Filed: September 17, 2010  
180th Day: March 16, 2011  
Staff: TRoss-SD  
Staff Report: September 29, 2010  
Hearing Date: October 13-15, 2010

REGULAR CALENDAR  
STAFF REPORT AND PRELIMINARY RECOMMENDATION

Application No.: 6-10-041

Description: The construction of a 38,600 sq ft Marine Ecosystem Sensing, Observation, and Modeling (MESOM) research and education facility, including a three story laboratory, office, conference and support space, at a location currently utilized by two parking lots (Lot Nos. P012 & P013).

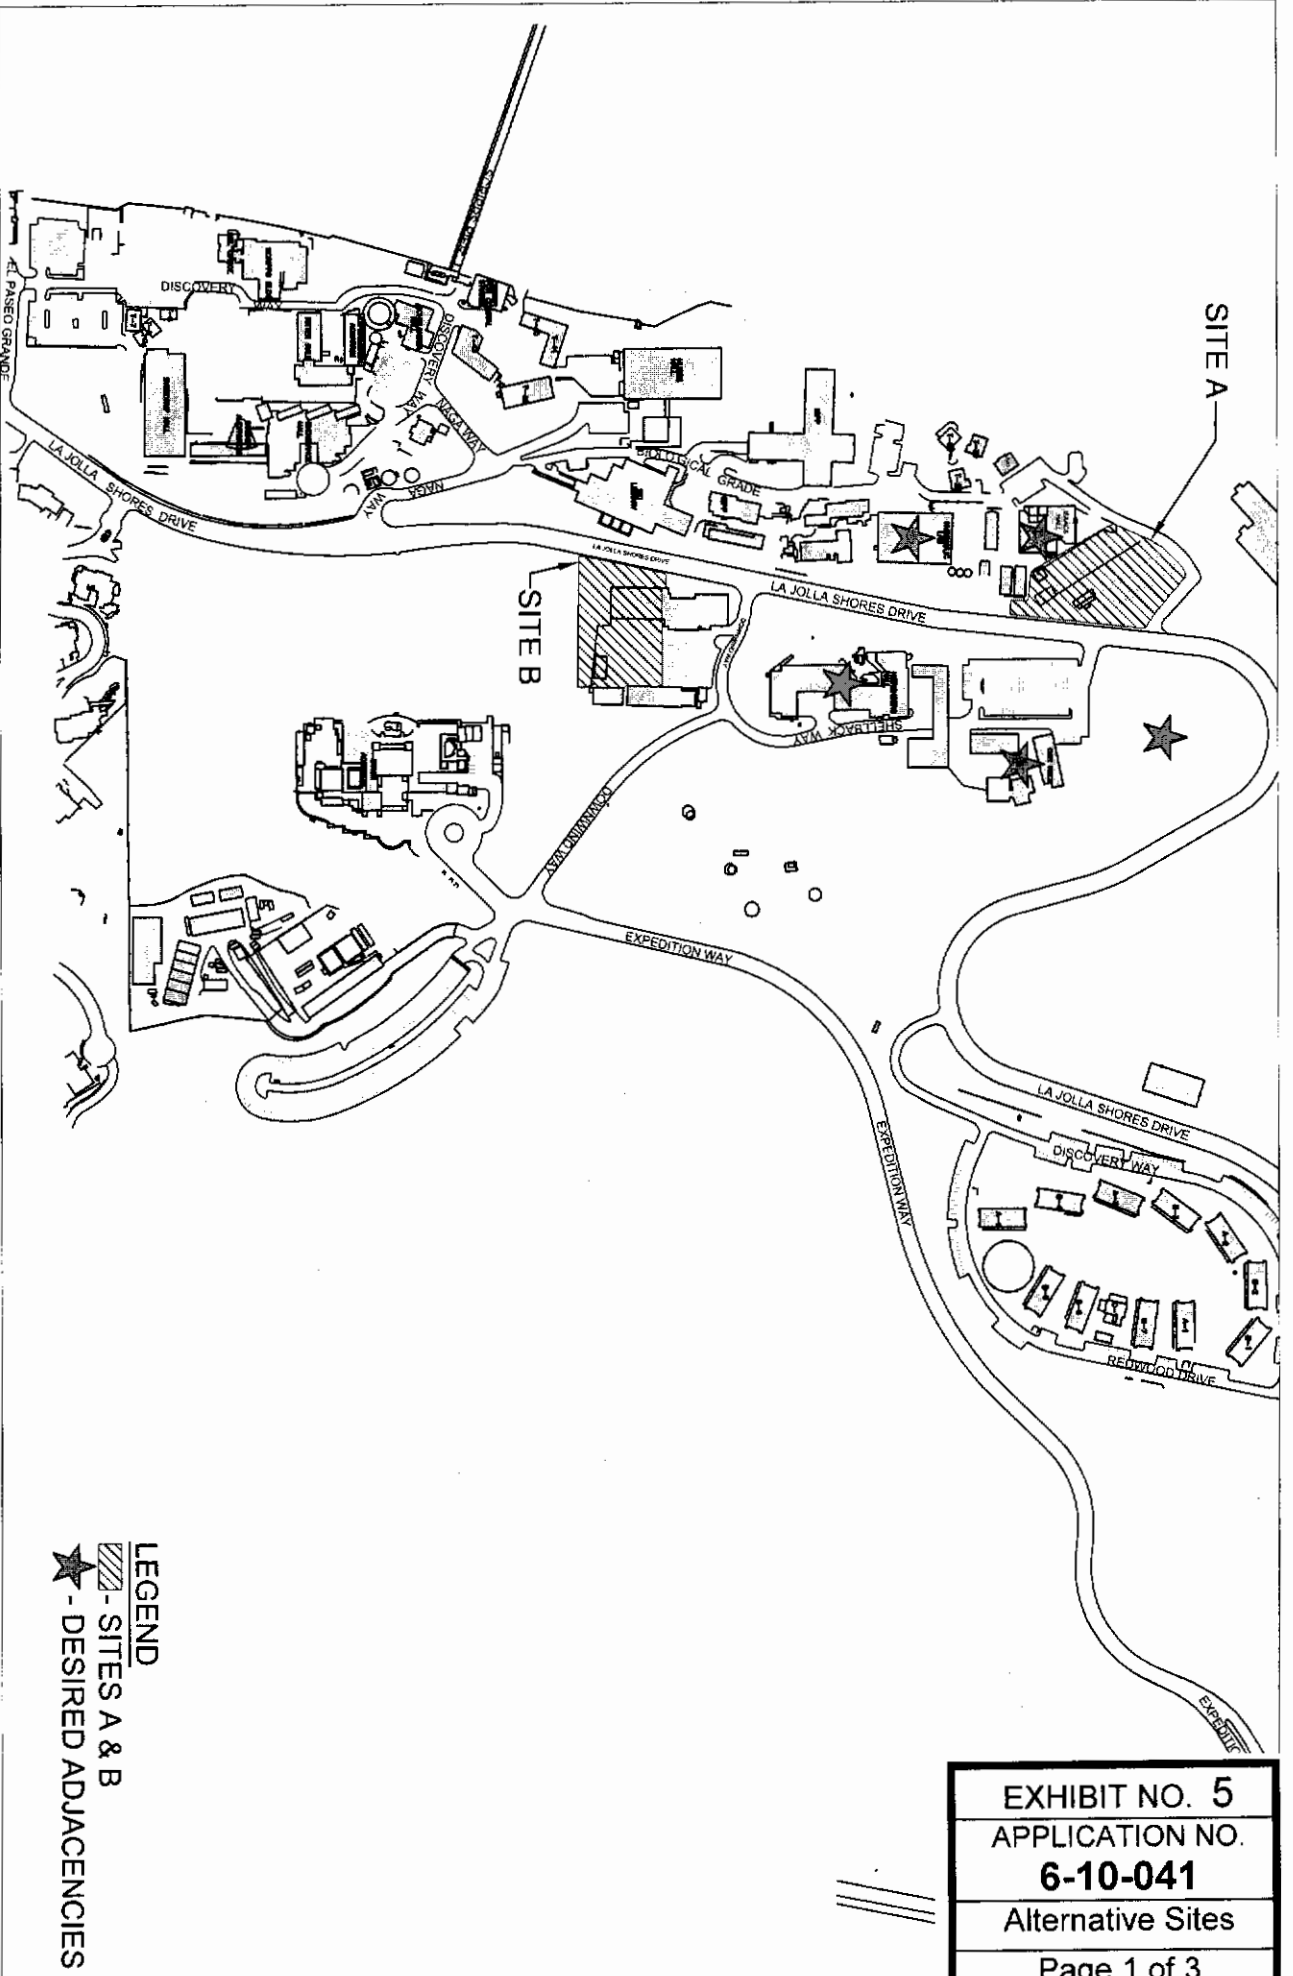
The proposed structure will result in partial to full view blockage of these significant views from all vantages (ref. Exhibit #4).

EXHIBIT NO. 5
APPLICATION NO.
<b>6-10-041</b>
Alternative Sites
Page 1 of 3
California Coastal Commission

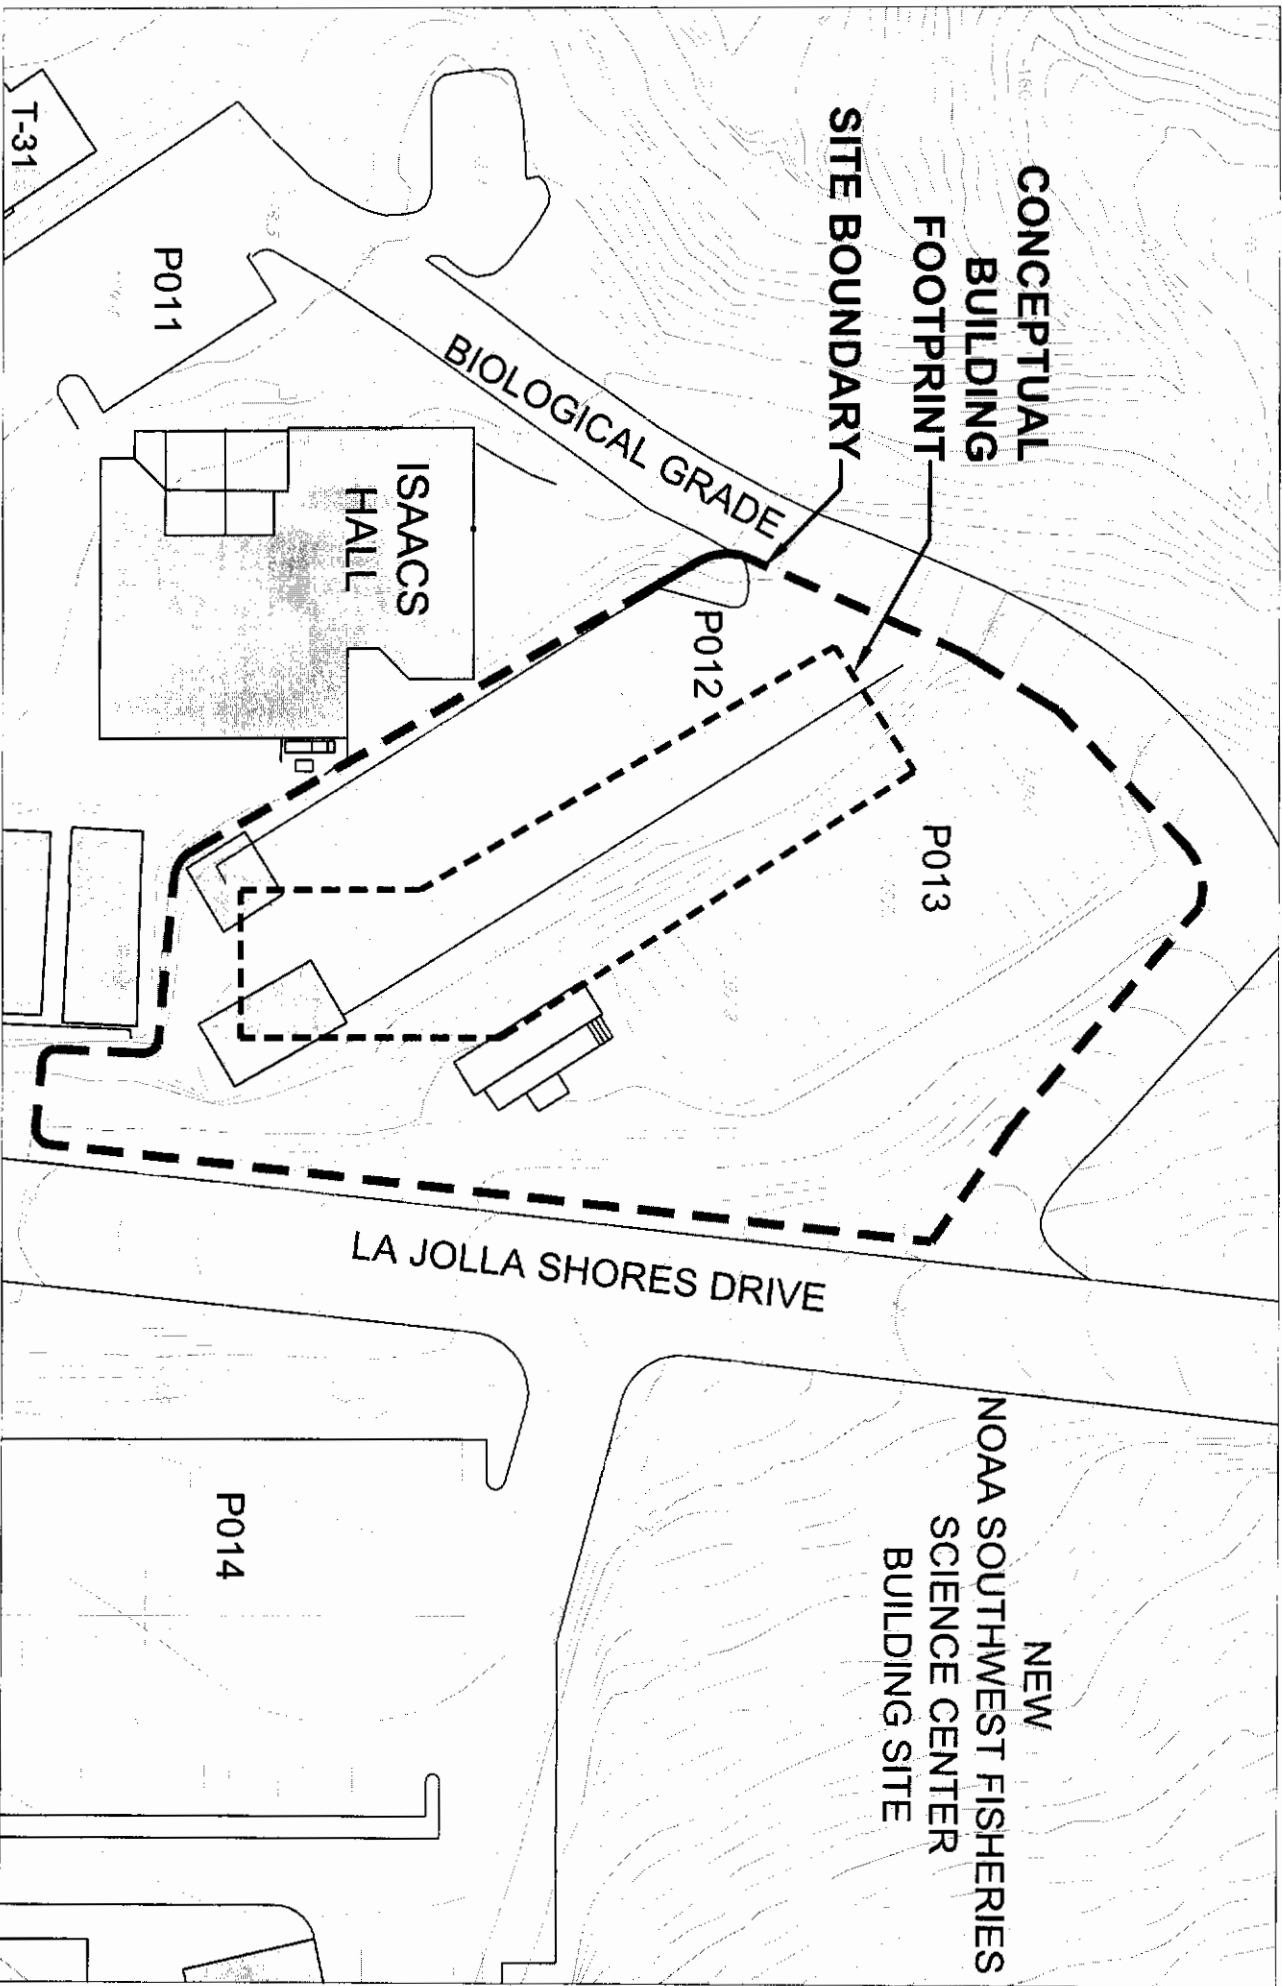
The other alternative site reviewed by UCSD is the Deep Sea Drilling (DSD) site, located just south of the proposed MESOM site, and on the east side of La Jolla Shores Drive (ref. Exhibit #5). This building site is not located in the CO Neighborhood but would still be within walking distance of Isaacs Hall, the Hydraulics Lab, SWFSC, the KECK facility and Nierenberg Hall. However, service truck accessibility would be limited to one side and level of the building as opposed to two sides being available at the current proposed location. UCSD concluded that this limitation would significantly limit the number of laboratories accessible to the service yard. As previously discussed, direct access by the labs to the service yard is one of the primary objectives for the MESOM facility, and, as such, UCSD also eliminated the DSD site as an alternative.

The Commission disagrees that the two alternative sites are not feasible locations for the MESOM facility, particularly given the concerns associated with the chosen project site. Compromises such as having buildings located beyond what UCSD considers an acceptable walking distance, or non-ideal access to the service yard should not be disregarded. While the Commission understands that the proposed location may be the most desirable based on building design requirements and its adjacency to other marine science buildings, it still must be found consistent with the Coastal Act, and thus, cannot significantly obstruct valuable existing public views.

EXHIBIT NO. 6  
APPLICATION NO.  
**6-10-041**  
Figure 9 of La Jolla Shores Community Plan

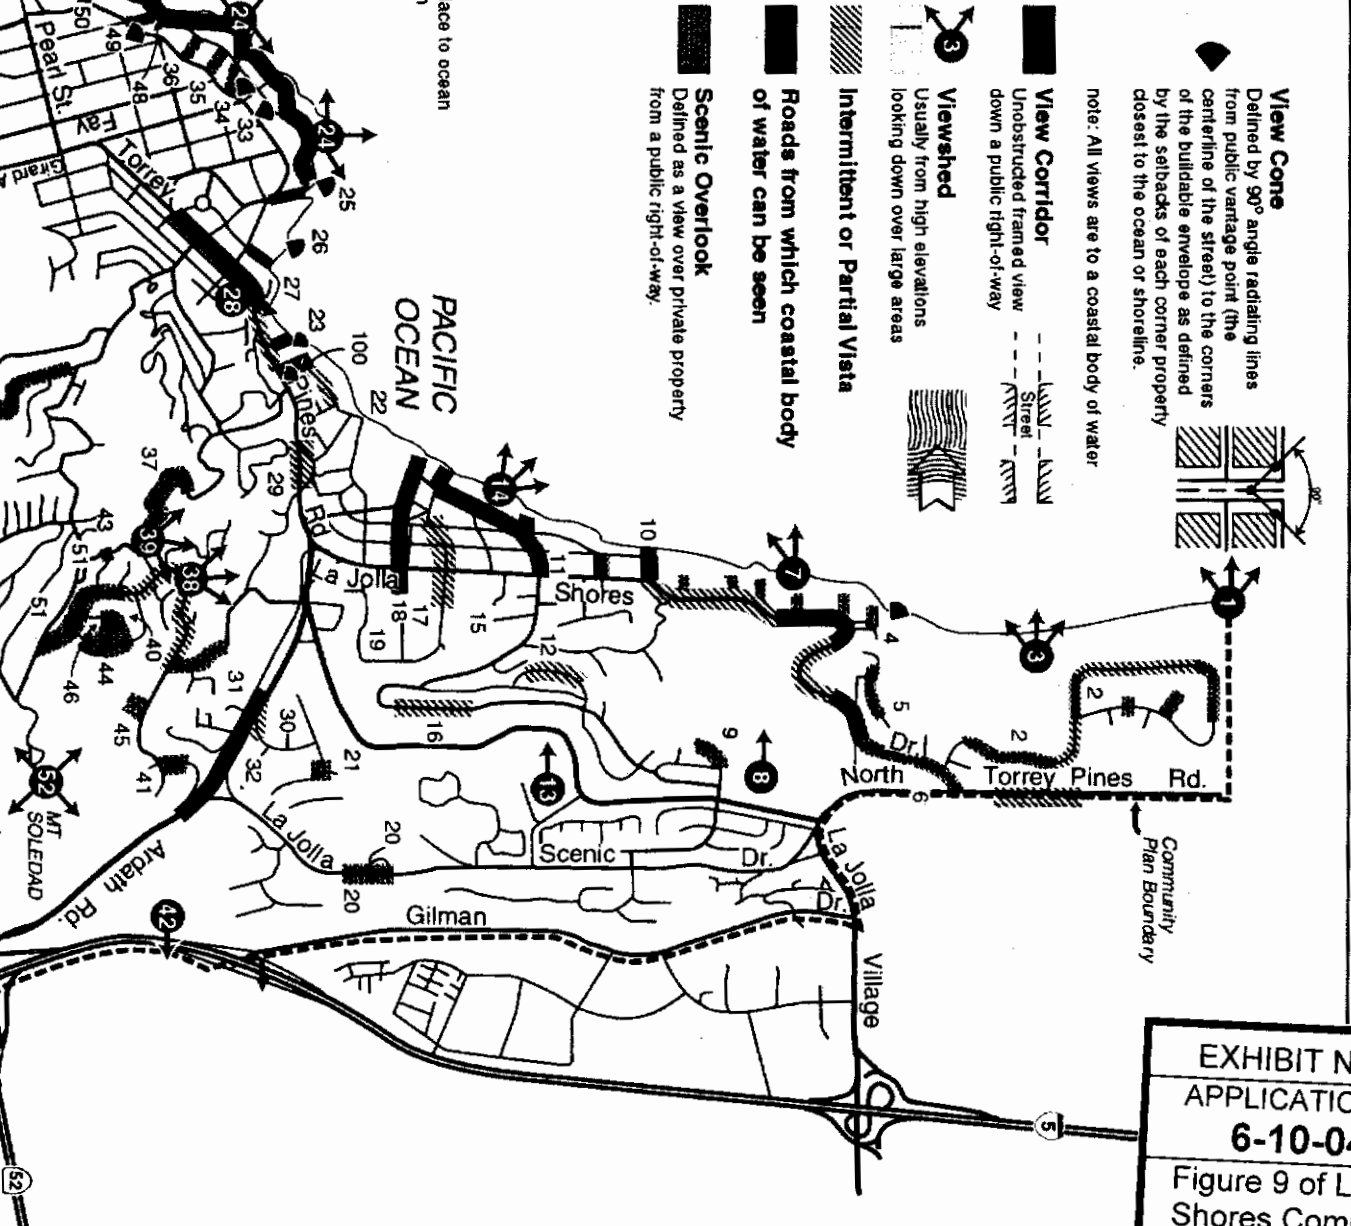
Figure 9 of the La Jolla Community Plan also identifies La Jolla Shores Drive as an area that contains scenic overlooks, intermittent or partial vistas, and is also considered to be a road from which the Pacific Ocean can be seen (ref. Exhibit #6).

**EXHIBIT NO. 7**

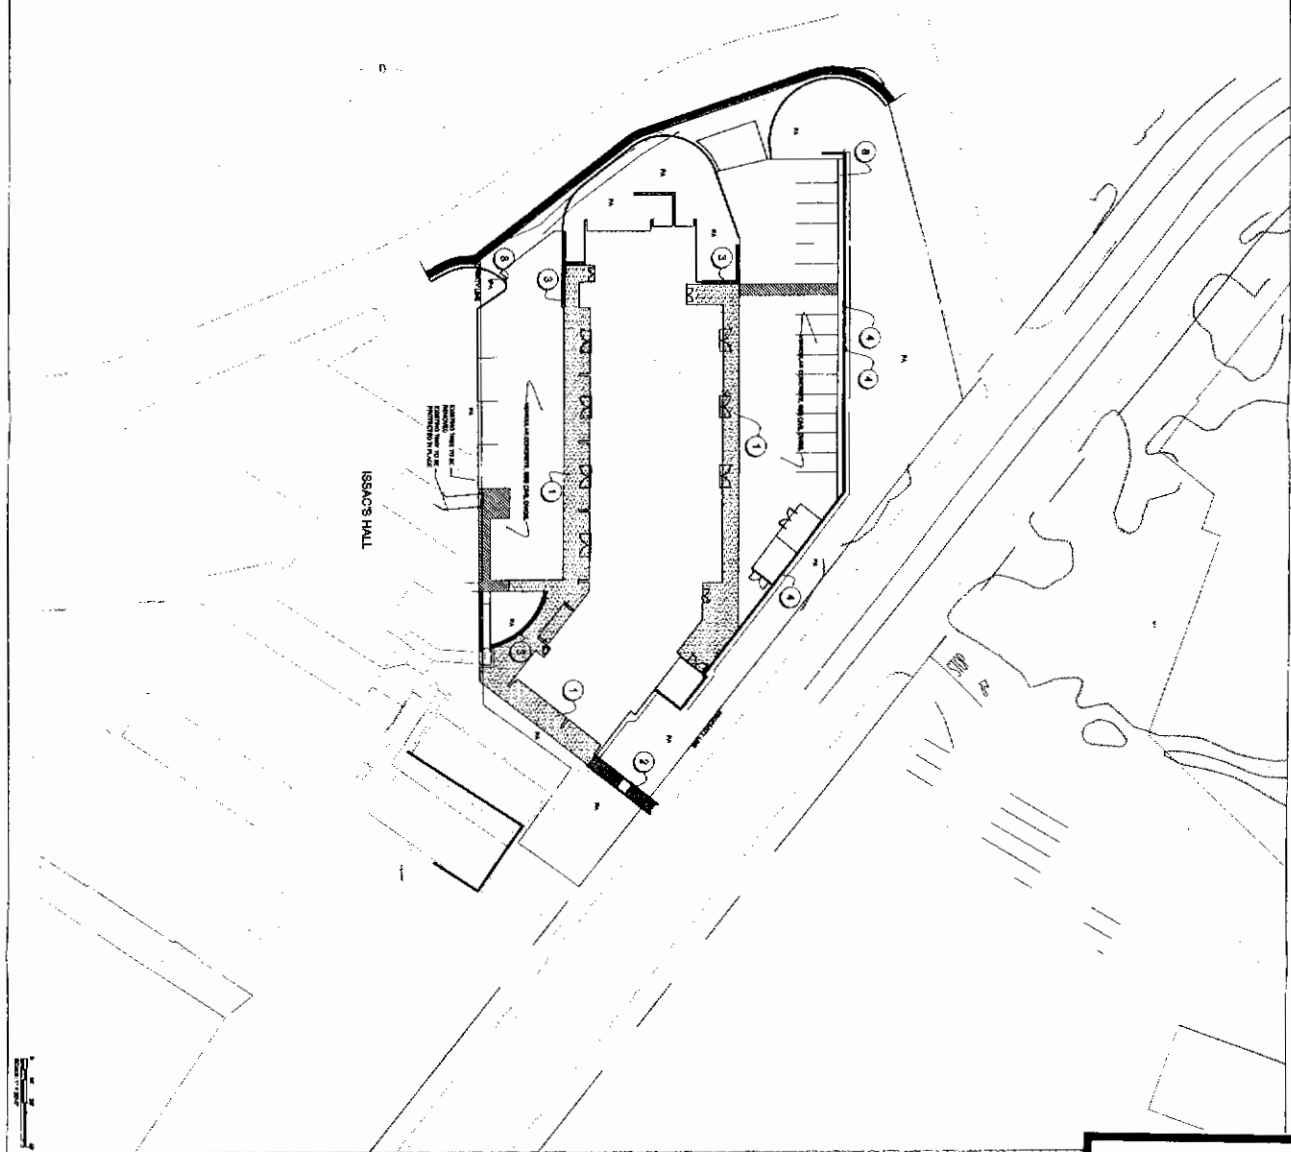
Two driveways, both accessed from Biological Grade, would provide vehicular access to the project site. The upper yard would provide the majority of parking spaces (15 spaces), and the lower yard would include parallel parking for the remaining five spaces. During periodic loading and unloading of laboratory equipment, the five parking spaces along the southern side of the building would be temporarily unavailable for automotive parking (ref. Exhibit #7).
